RE: Lighting RFP motion that is still before us

6/8/2008 – 7/9/08

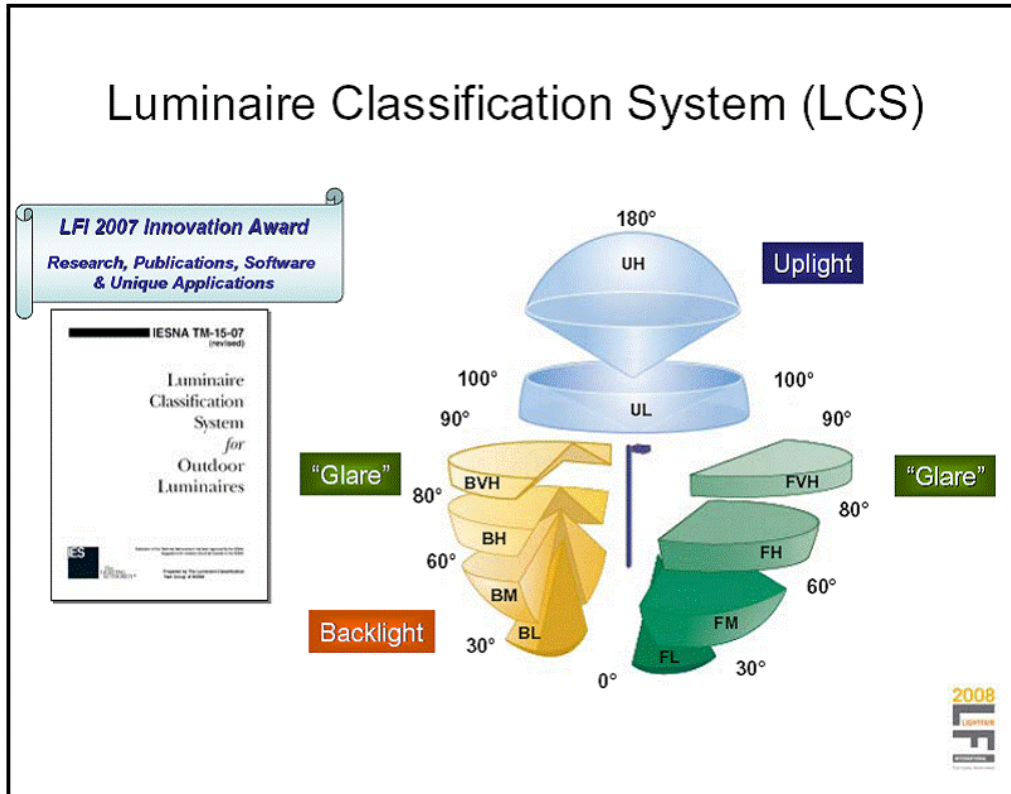
The old IESNA cut off system (full cut off, etc.) is now deprecated by TM-15-07 which establishes a better and more complete system. From the standpoint of glare, the 80-90 degree zone (just below horizontal) is most critical and needs to be limited to approximately the definition of full cut off. The 90-110 degree zone produces the most severe sky glow and needs significant restriction. However, a really good luminaire can have a tiny bit of uplight including the 90-110 zone due to a clear lens or even the top of a pole just below the light. FCO purists eliminate this potentially superior group of luminaires, many of traditional style, due to this meaningless photometric anomaly.

Therefore, a better photometric rating system should be used based on TM-15 and local objectives (the "BUG" system, that I will be presenting today at LightFair, is just such a system. Backlight Uplight Glare).
